AMENDMENTS TO THE DRAWINGS

REMARKS

Fig. 3

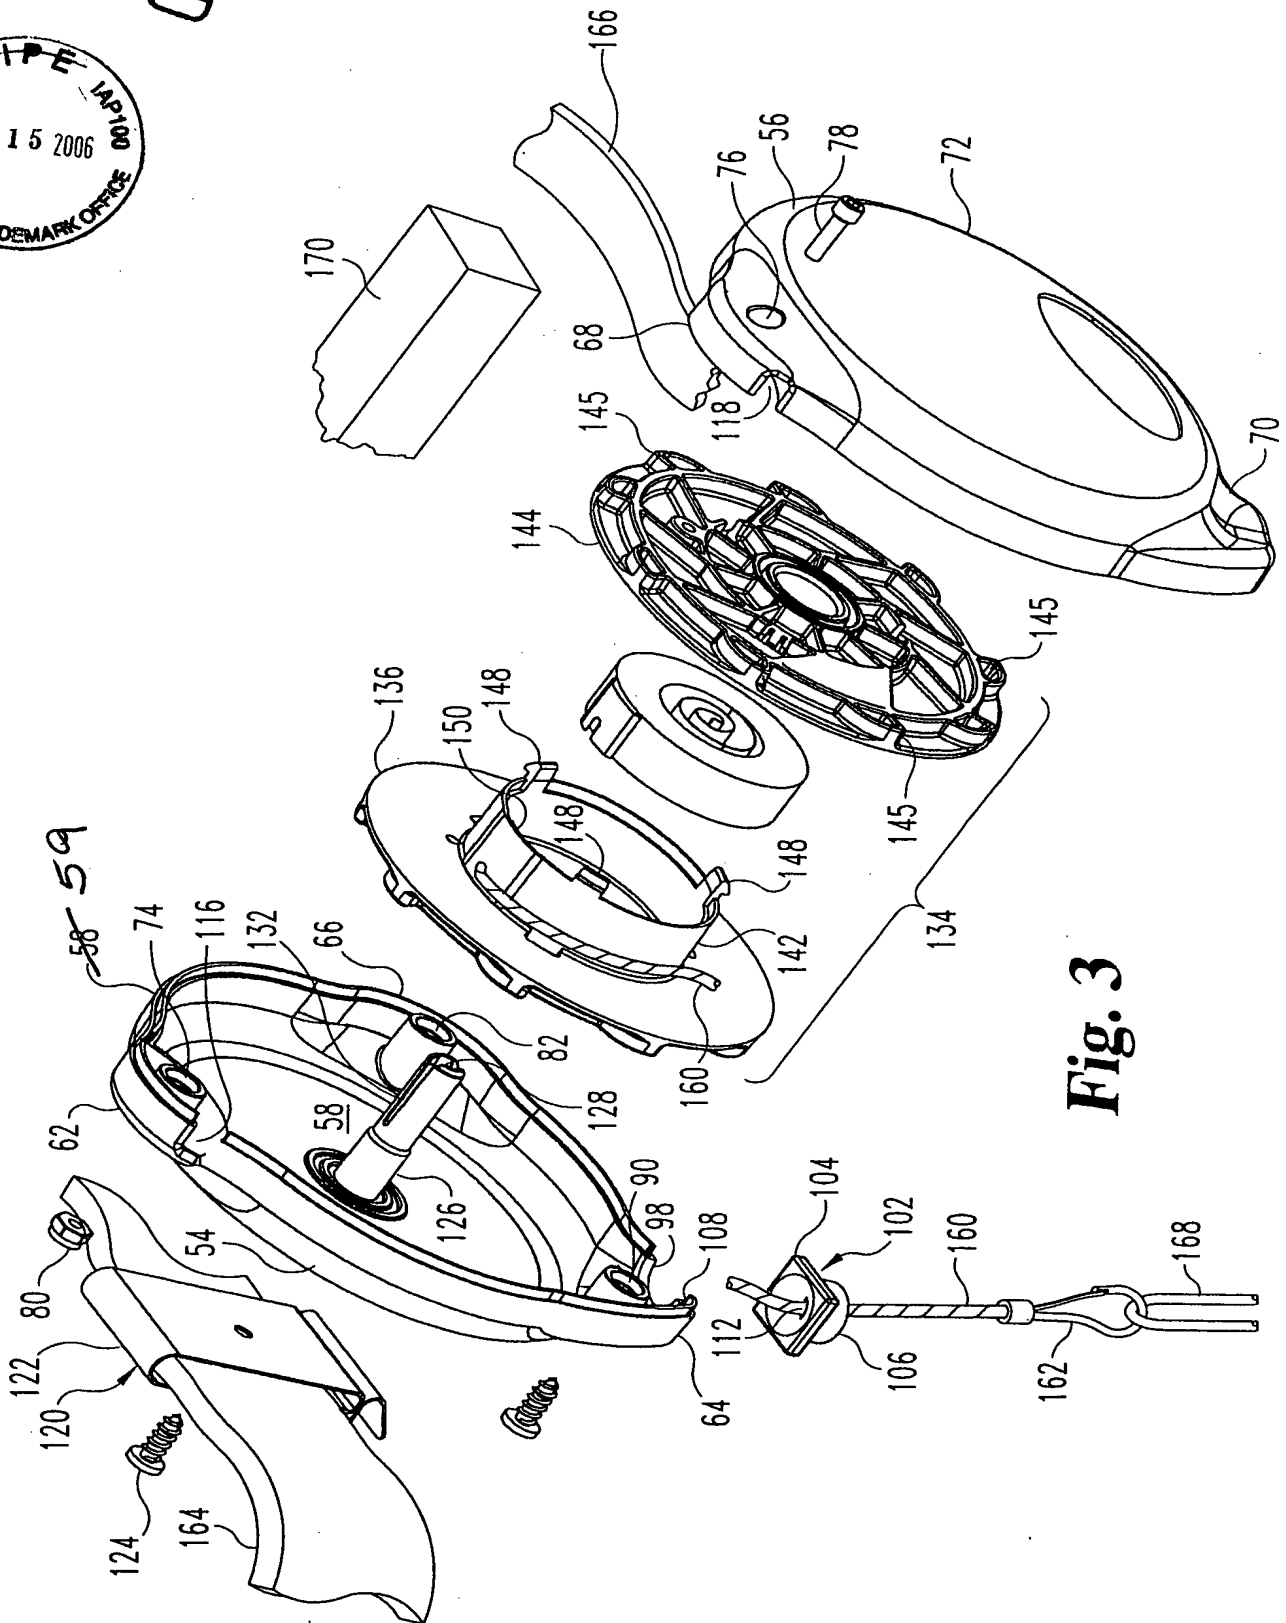
Drawing sheets containing Figures 3 and 4 have been submitted to cure the objections pointed out by the Examiner. For Figure 3, reference character 58 designating the perimeter flange has been changed to 59, thereby avoiding duplication. In Figure 4, the unnamed screw at the upper right corner of the drawing has been designated 78, as well as nut 80 in the lower left hand corner of the drawing to conform with the reference characters of Figure 3. It is believed that these amended drawings comply with the requirements of 37 CFR 1.121(d). Two sheets of red-marked drawings are enclosed. Anticipating approval of the drawing amendments by the Examiner, two replacement sheets are also being forwarded. Accordingly, the objection to the drawings is appropriate to be withdrawn.
